Tailings aspects of Fingerboards Environment Effects Statement, Glenaladale, Victoria: Expert witness statement

19 January 2021

Report title
Review of tailings aspects of Fingerboards Environment Effects Statement, Glenaladale, Victoria: Expert witness statement

Figure 8-2: TSF configuration (plan view)

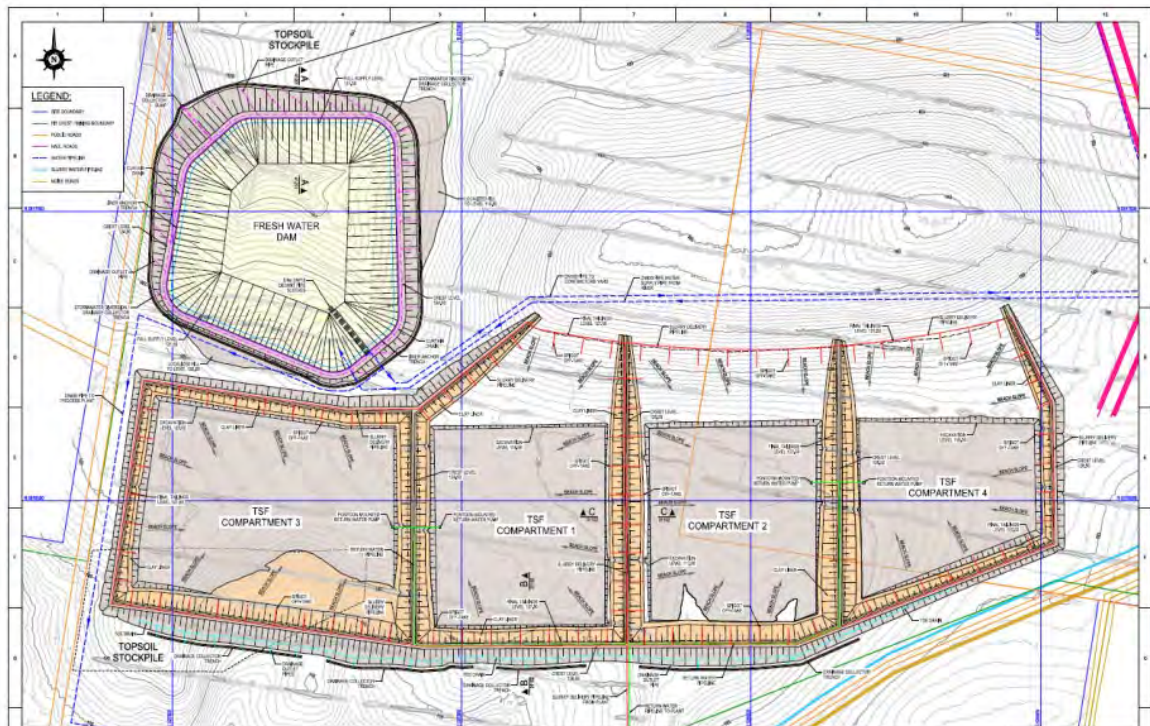
45. The EES does not present a discussion of leachate infiltration into the surrounding landscape from the floor of the tailings storage facility or mine void. Infiltration through the tailings storage facility lining is anticipated, as outlined in Points 42 to 44 above. To understand what infiltration through the floor of the lined tailings storage facility and mine void might look like, an understanding of the site topography (that is the lay of the land — where the hills are relative to the rivers etc) is needed. A diagram presenting the location of the tailings storage facility was presented in Section 8.5.2 of Attachment B of the EES as follows, with an additional diagram drafted by me presented after the EES diagram, to show the location of the tailings storage facility and mining void relative to the topography of the proposed mining location:

46. The diagrams show that the tailings storage facility is to be located on a shallow ridge line between four catchments — these are the Long Marsh Gully catchment; the Lucas Creek catchment; and the Perry Gully catchment; and the Perry River catchment (Attachment B, Section 8.5.1):

Figure B-3: Sand Tailings Seepage Monitoring and Management (After EMM, 2020b)

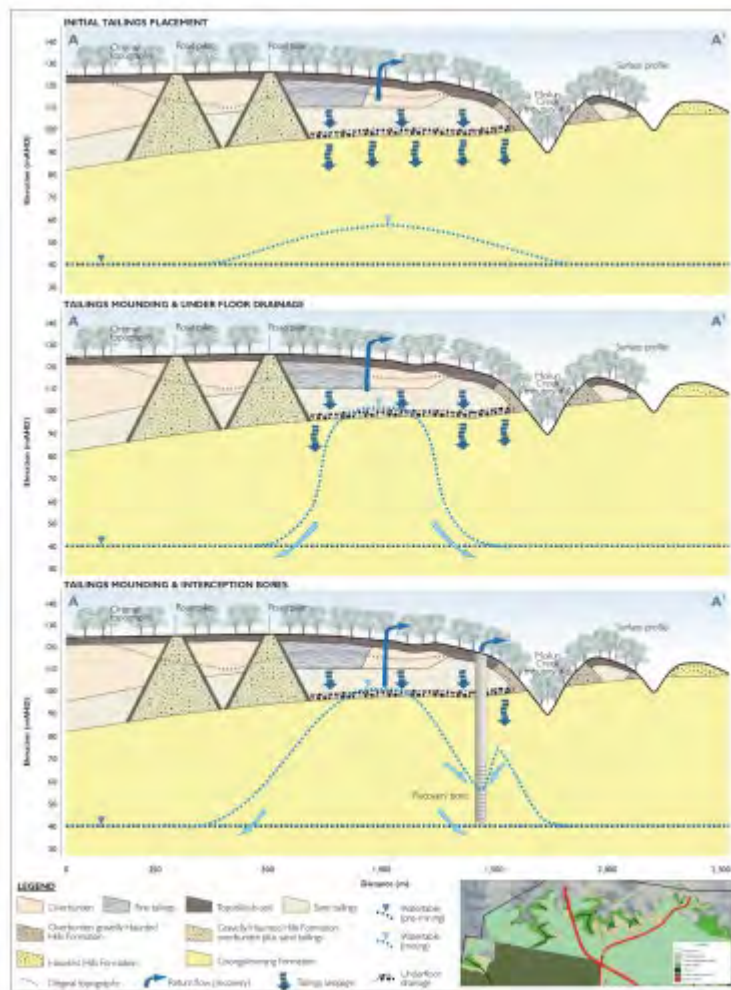
51. A schematic conceptual diagram of tailings monitoring and seepage is also presented in Attachment B, Section 8.5.6:

Figure B. Conceptual diagram depicting how contaminants may move from the tailings storage facility into the surrounding landscape.

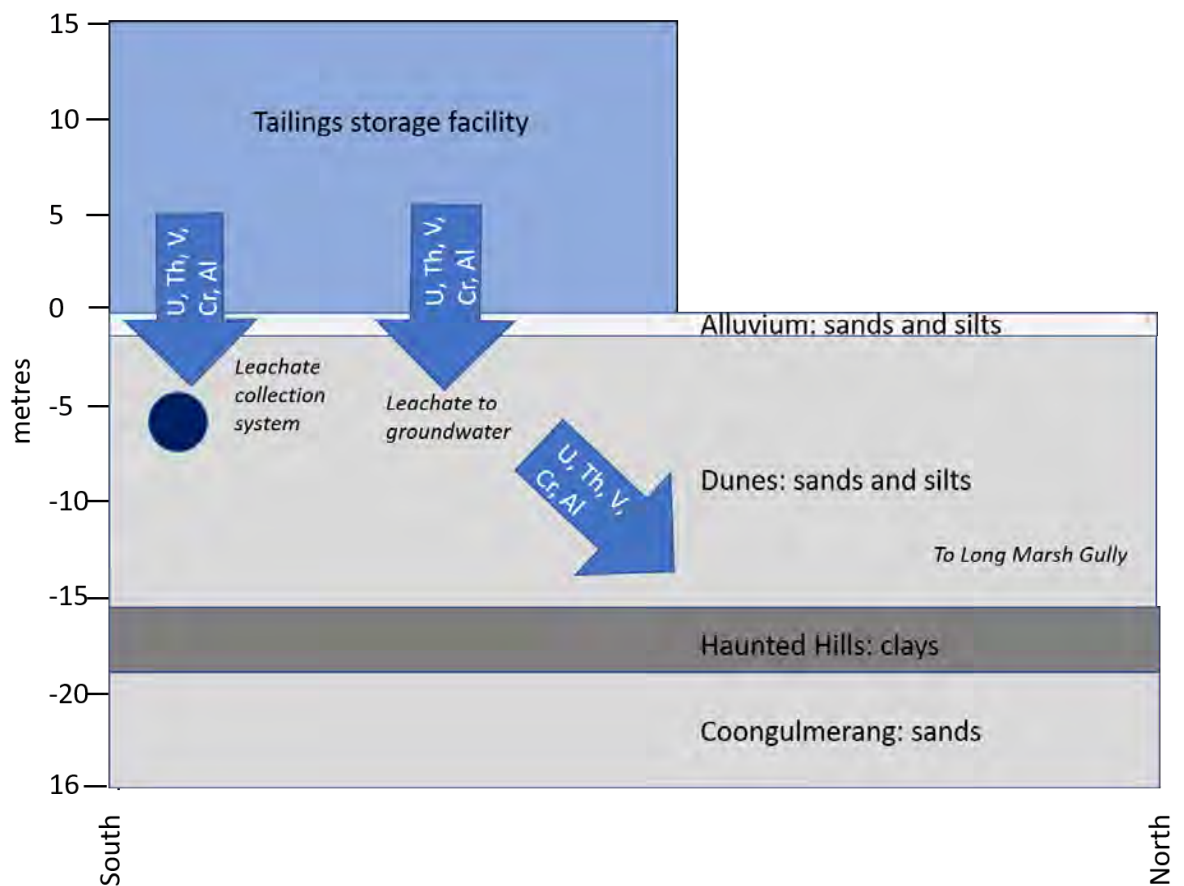
52. To aid my understanding of the potential impacts of tailings stored in the tailings storage facility relative to the surrounding geology, I made the following diagram:

53. The diagram presented in Point 52 is based on the tailings storage facility being located on a shallow ridge line between four catchments — these are the Long Marsh Gully catchment; the Lucas Creek catchment; and the Perry Gully catchment; and the Perry River catchment, and the site topography of those locations (Point 45). As such, it is one of four similar diagrams that could be made for the tailings storage facility. Three others could be made that would be the same, except for showing that leachate could move through the floor of the tailings storage facility into the Lucas Creek, Perry River, and Perry Gully catchments. This shows that leachate that moves through the floor of the tailings storage facility could discharge into the sands and silts that occur within the Pleistocene dunal deposits at a depth of between 2 and 10 metres

Figure C. Conceptual diagram depicting how contaminants may move from the mine void into the surrounding landscape.

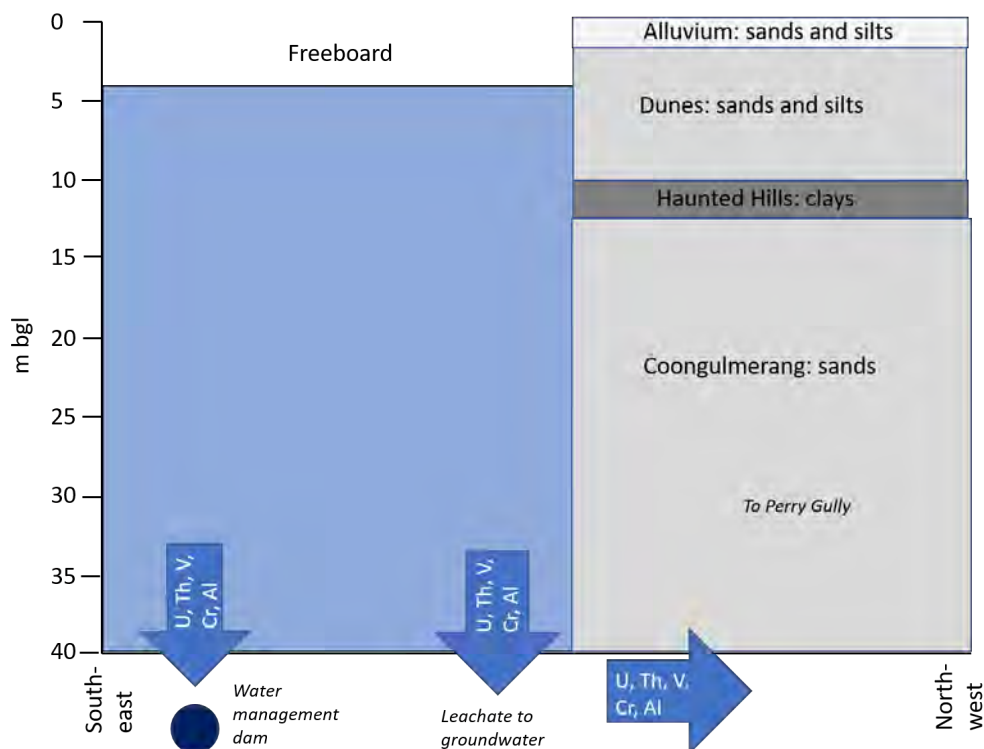
The location of the mine void across a ridgeline means that leachate could also infiltrate the dune sediments at this location and move into an unnamed tributary of the Mitchell River.
